ANN ARBOR HISTORIC DISTRICT COMMISSION

Staff Report

ADDRESS: 514 West Madison Street, Application Number HDC13-194

APPLICATION: The applicant seeks HDC approval to install a new dormer on the rear elevation of the third-floor attic for emergency egress, and shorten a first-floor kitchen window on the east side elevation of the rear addition.

THIRD FLOOR
Egress.

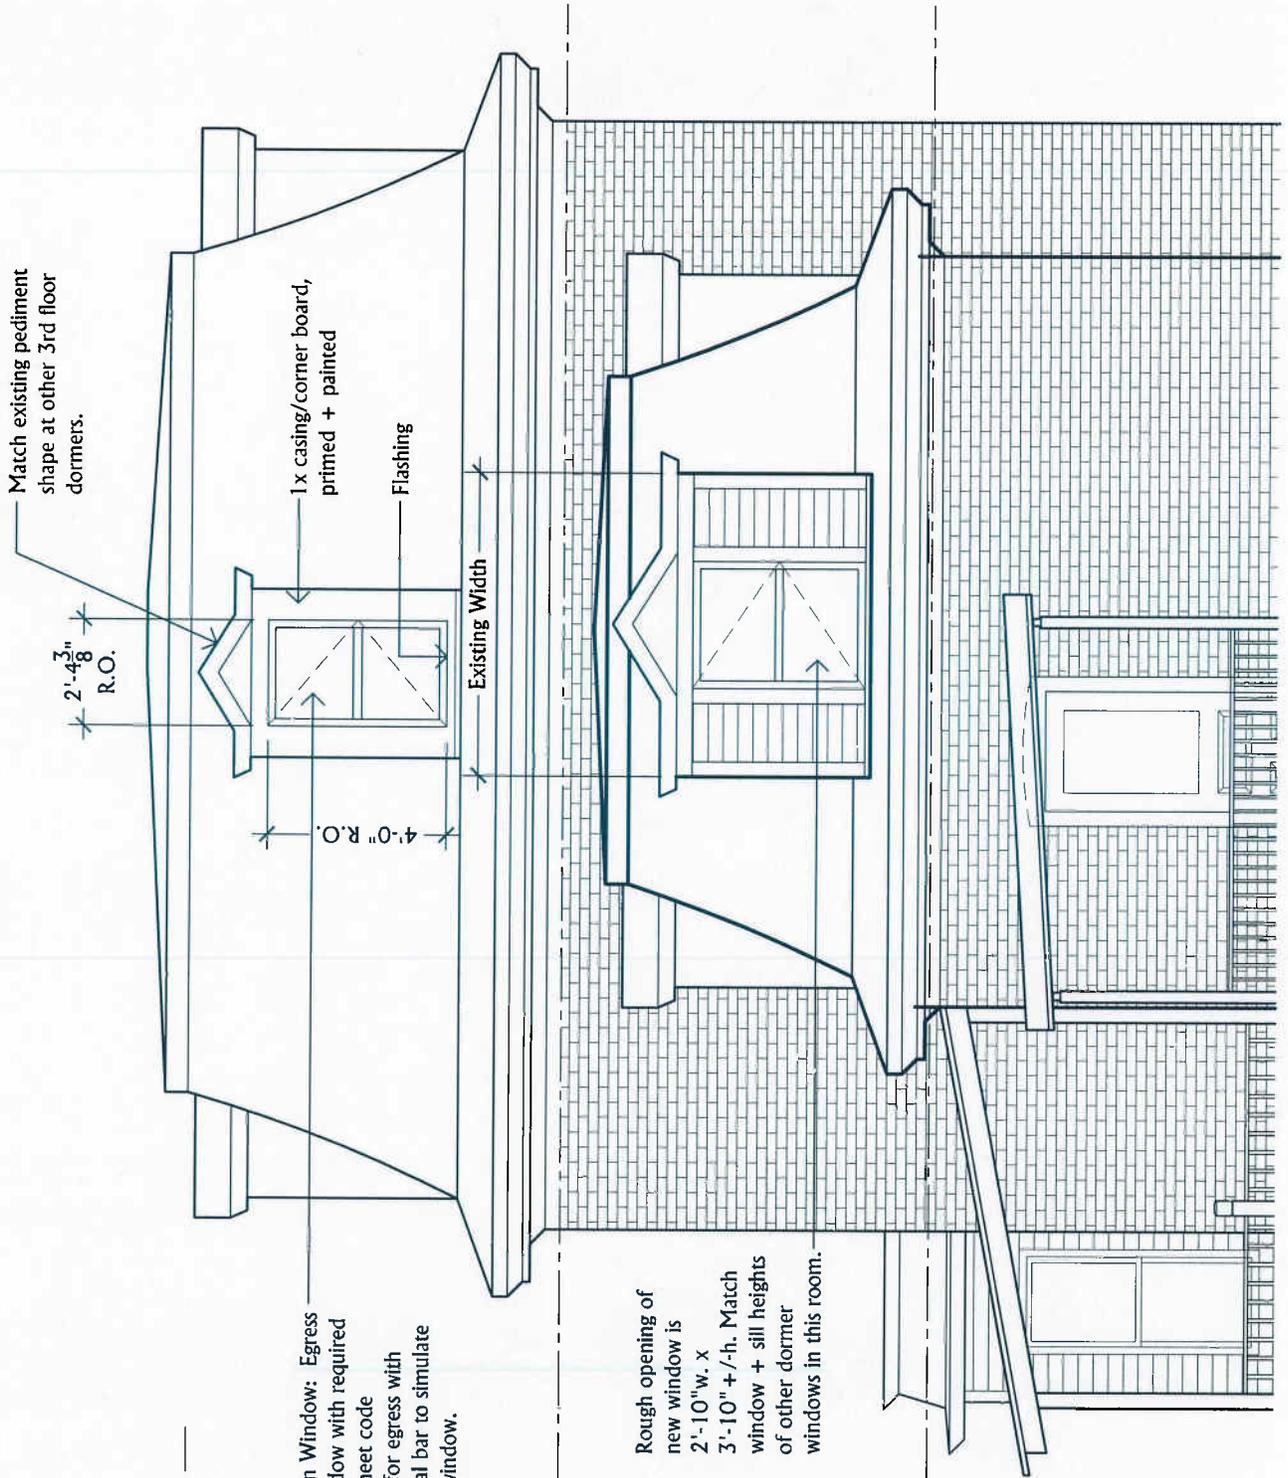
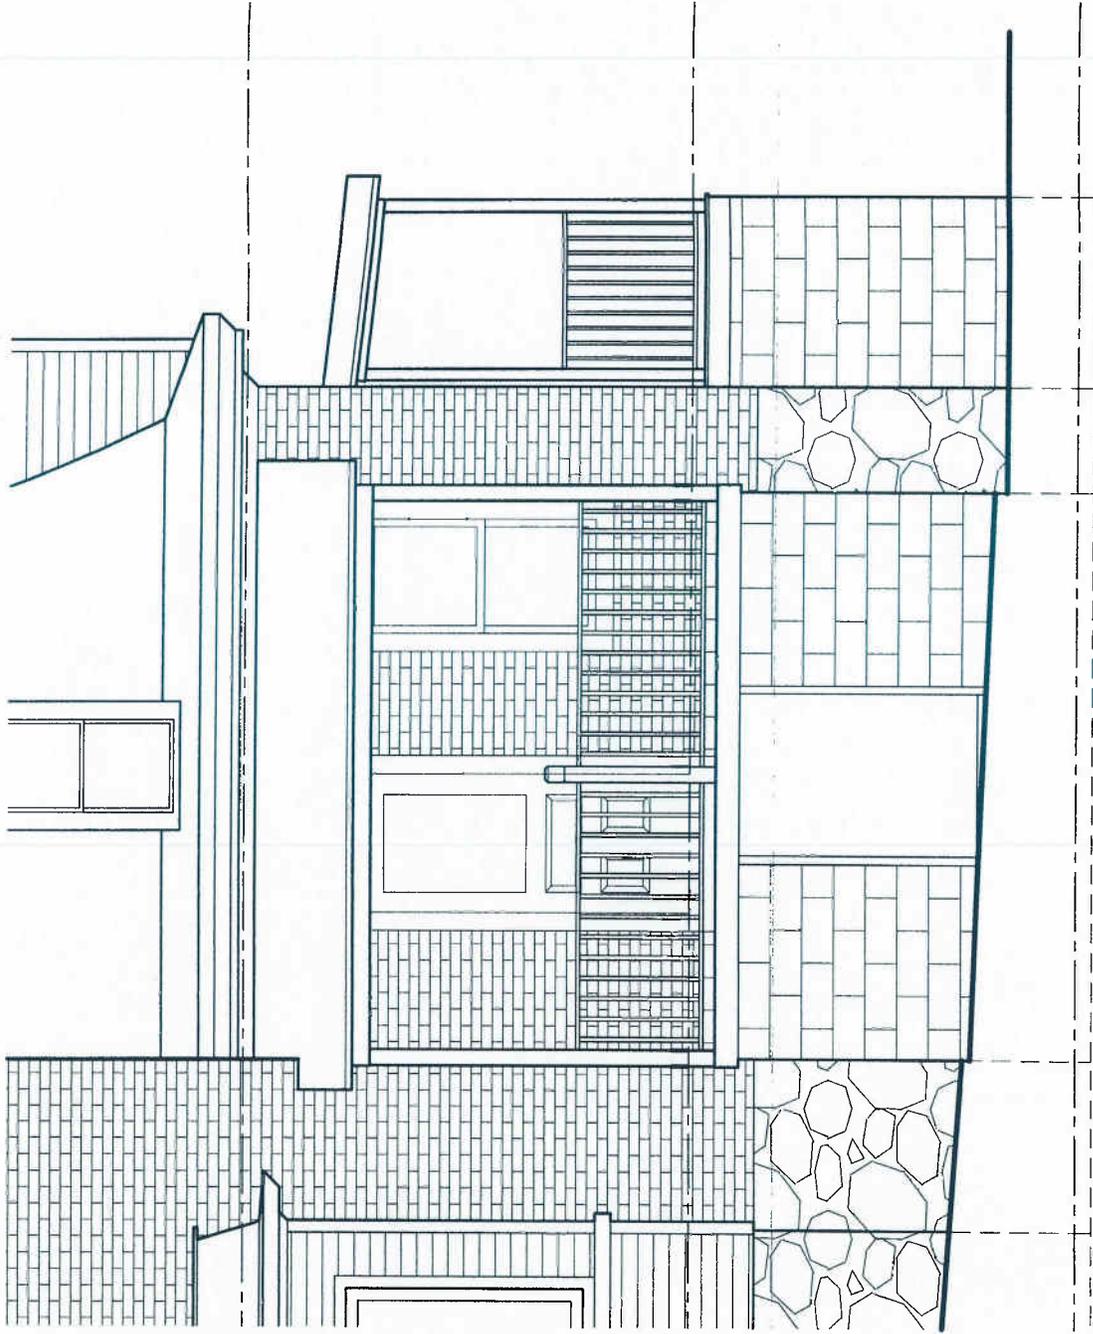
1. The third floor (attic) egress window would be added to the rear elevation and set into the mansard roof. There are three other dormers in the attic, but they are not large enough to retrofit with a new egress window, per the applicant. Considering that the existing dormers are character-defining features of the house, it is preferable to leave them alone anyway. Constructing a new dormer on the back elevation of the roof is appropriate, and matching the style of the existing dormers is acceptable since the overall dimensions will not match the originals – specifically, the new window, and its surrounding dormer, will be 2” shorter and 5” wider than the existing ones.

LOCATION: 514 W. MADISON - "REVISED" KITCHEN WINDOW ELEVATION - SCALE: 1/4" = 1'-0" SK. 3
 48103 "EAST ELEVATION"

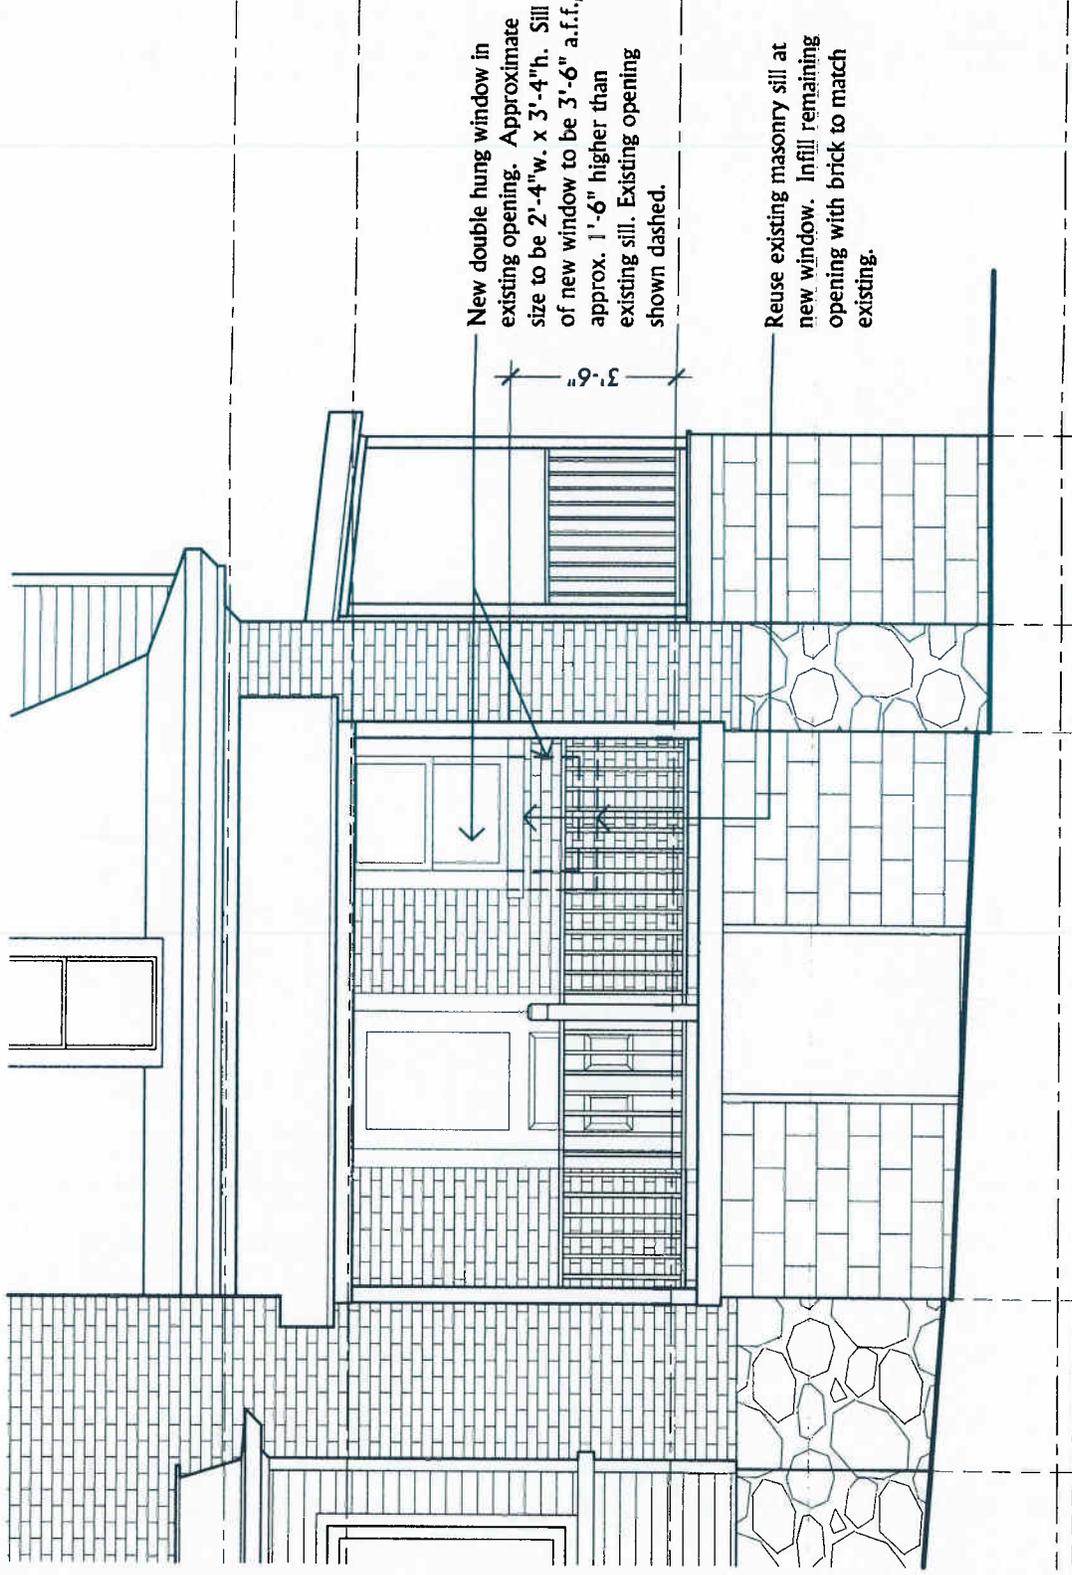
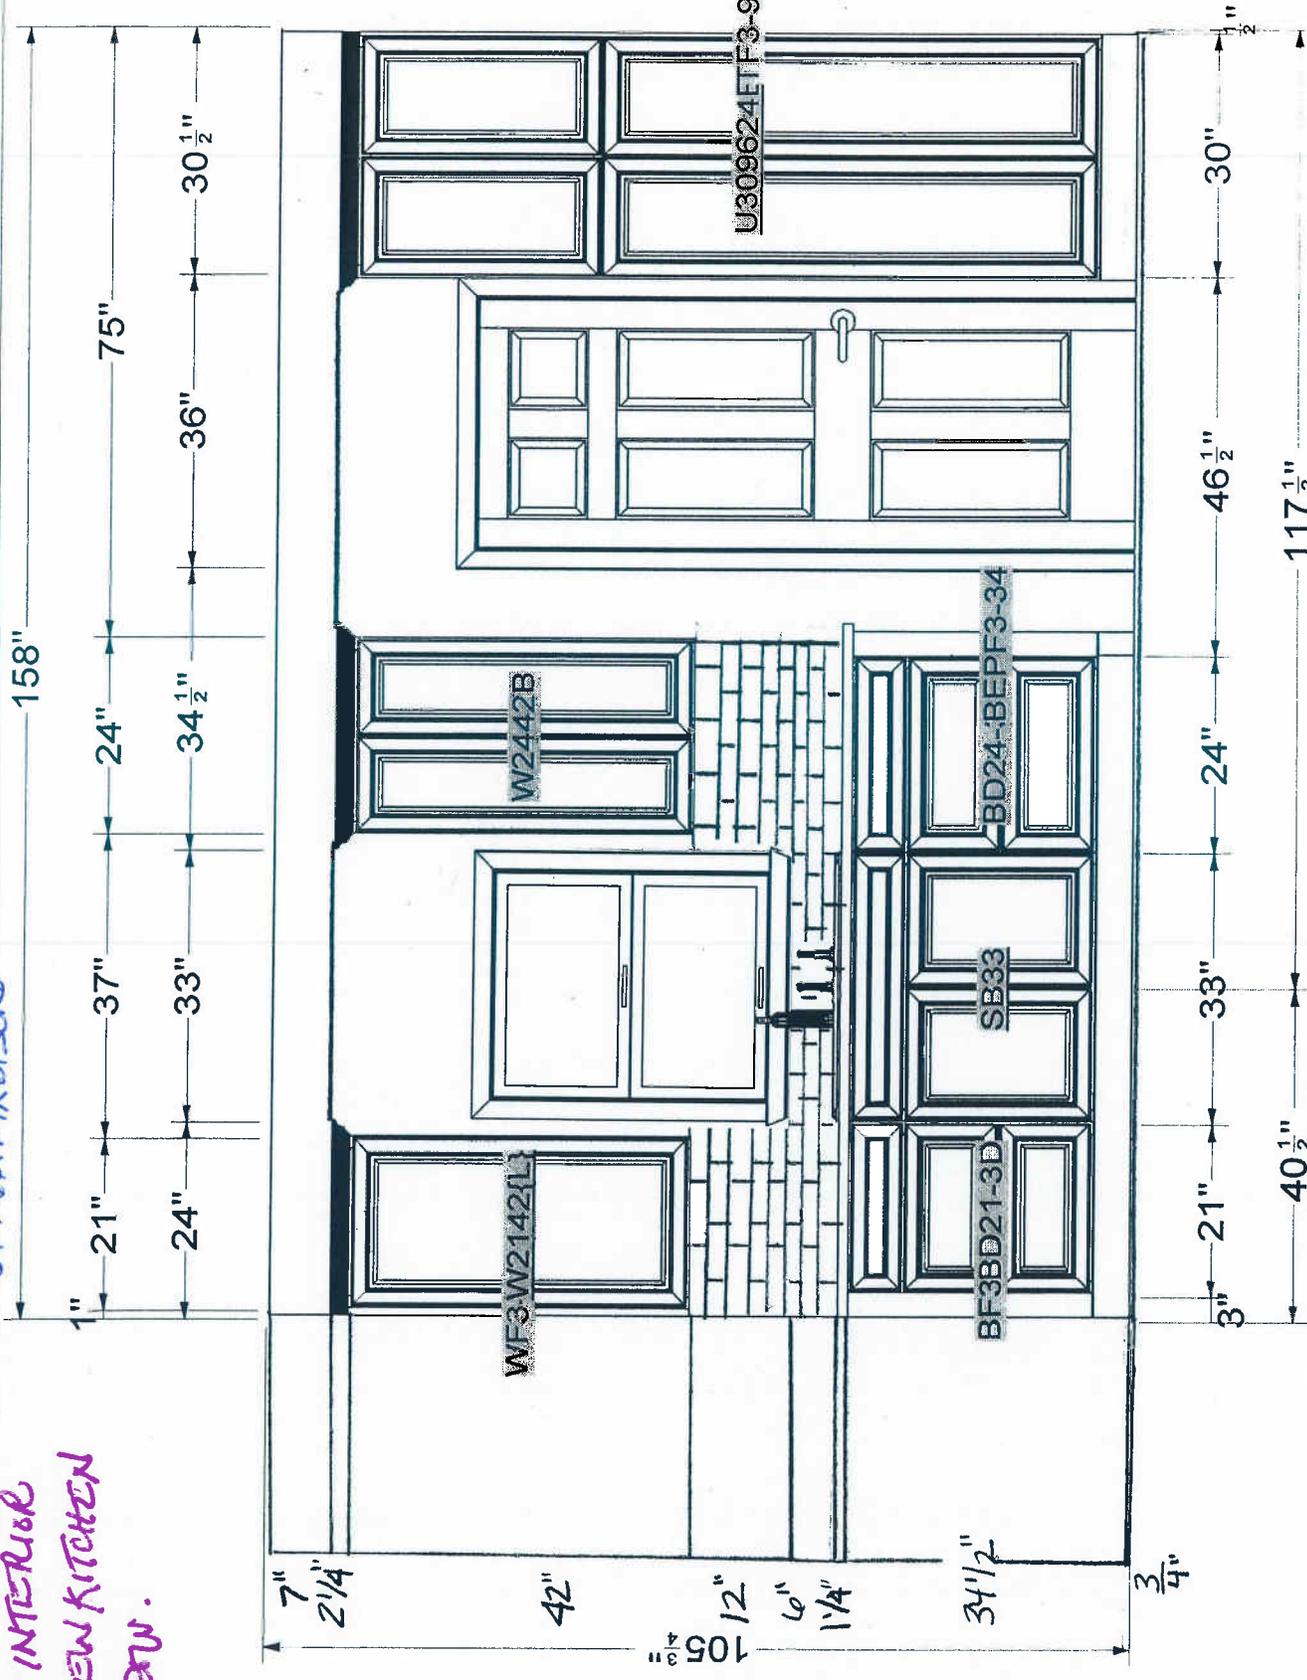
2. The kitchen window would be shortened 18” by raising and reusing the existing sill and infilling the area below it with matching brick. The applicant has indicated a willingness to inset the brick infill slightly and not tooth the new bricks in, in order to leave a record of the original height of the window. The internal configuration of the small kitchen is challenging, with five doors on the four kitchen walls plus this window. Shortening this window in order to gain space for a counter and sink is a reasonable modification in staff’s eyes, given its location under a porch roof near the back of the house. Insetting the brick to leave a record of the original window height is appropriate, and the proposed new window matches the other Andersen replacement windows on the house that were necessitated by the fire.
